**Chain Valley Colliery (SSD 5465)
Miniwall S4 Extraction Plan**

Consideration of Approval of Miniwall S4 Extraction Plan

Figure 5: S2, S3 and S4 Miniwall (MWS2, MWS3 and MWS4) Surface Features (Strata2, 2019)

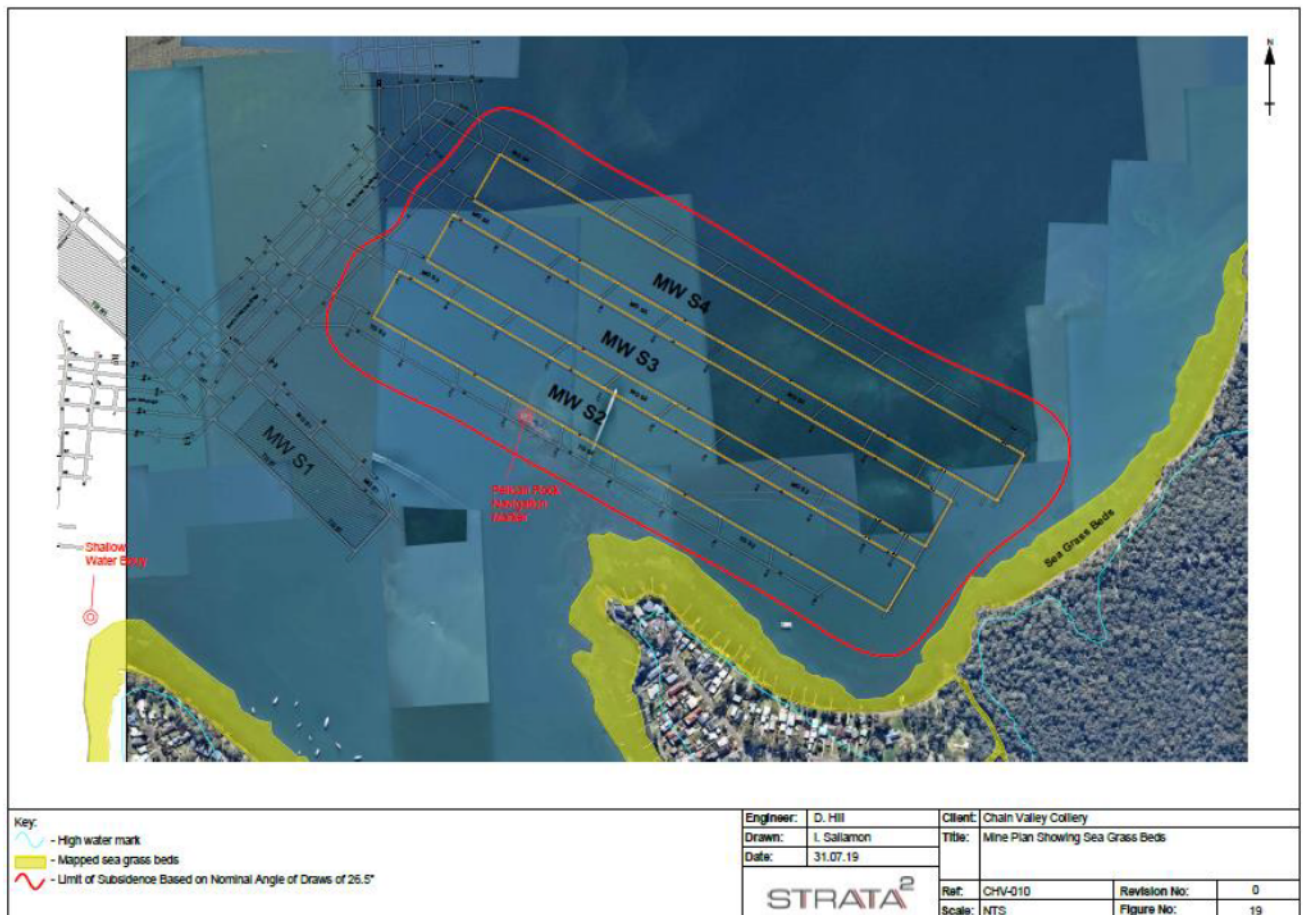
13. The SPB is similar to the HWMSB, only that its purpose is to protect seagrass beds that fringe the foreshore and extend to a depth of two metres within the lake. The line from the lakeside edge of the SPB is projected at an angle of 26.5 degrees to its intersection with the target coal seam. No secondary coal extraction, such as miniwall mining, is permitted within this zone. The figure below shows that the 20 mm subsidence contour (in red) skirts the seagrass beds.
